RE: COUNTYWIDE LANDFILL BERM CONSTRUCTION ALTERATION REQUEST APPROVAL

On March 7, 2008, Ohio Environmental Protection Agency (Ohio EPA) received an alteration request (via e-mail) for Countywide Landfill as designed in permit-to-install (PTI) number 02-14796 approved June 2, 2003. The submittal included plan drawings to alter construction of cell 8C. Specifically, the alteration submittal is a request to alter construction of the berm between cells 8A and 8C.

CELL 8A/8C SEPARATION BERM PLAN

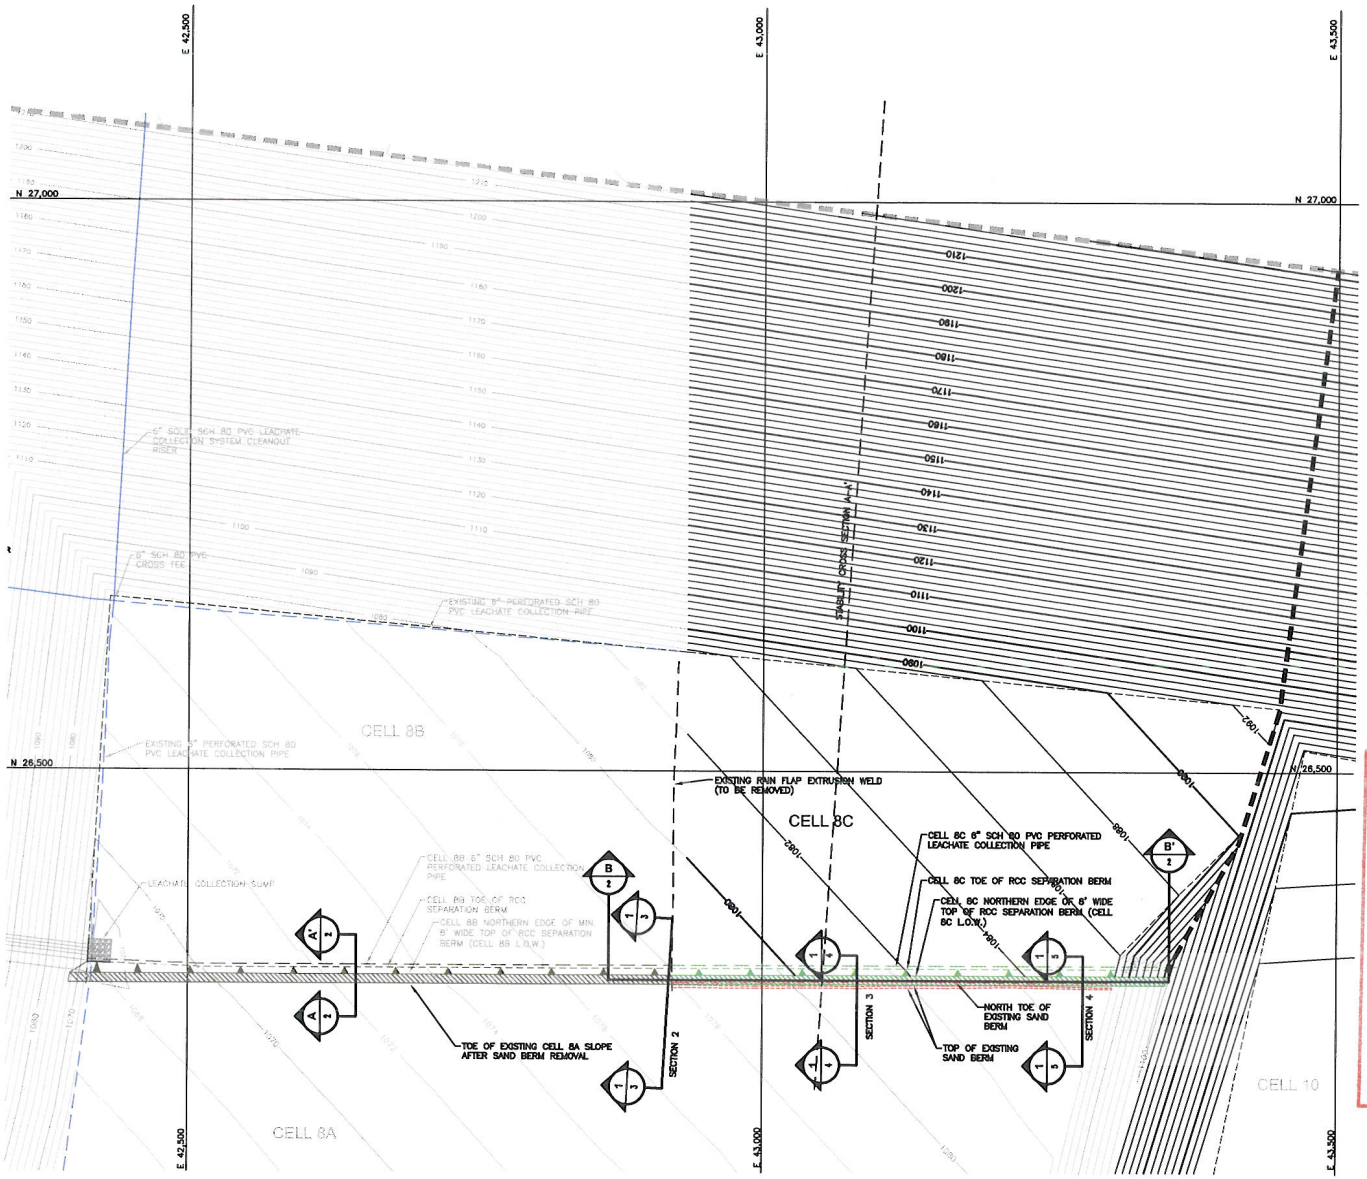
The alteration request includes soil fill between cells 8A and 8C with a maximum height of 32 feet that shall be constructed simultaneously with waste disposal in cell 8C. Ohio EPA understands that the purpose of this fill is for management of storm water from the interface of cell 8A with 8B and 8C and for operational purposes. The soil fill shall meet the same specifications as the soil fill between cells 8A and 8B.

Attached are the plans for the continuation of the OEPA-ordered firebreak between Cells 8A and 8C. Countywide needs to move into Cell 8C in the near future and therefore is requesting prompt approval of this design so that the berm can be constructed and certification documents submitted to NEDO as soon as possible.

The above noted alteration request as submitted on March 7, 2008, has been reviewed by Ohio EPA and appears to meet the intent of the design of the landfill as approved in PTI number 02-14796 and the Ohio EPA March 28, 2007 Orders. Ohio EPA NEDO hereby approves the above noted alteration requests to PTI Number 02-14796.
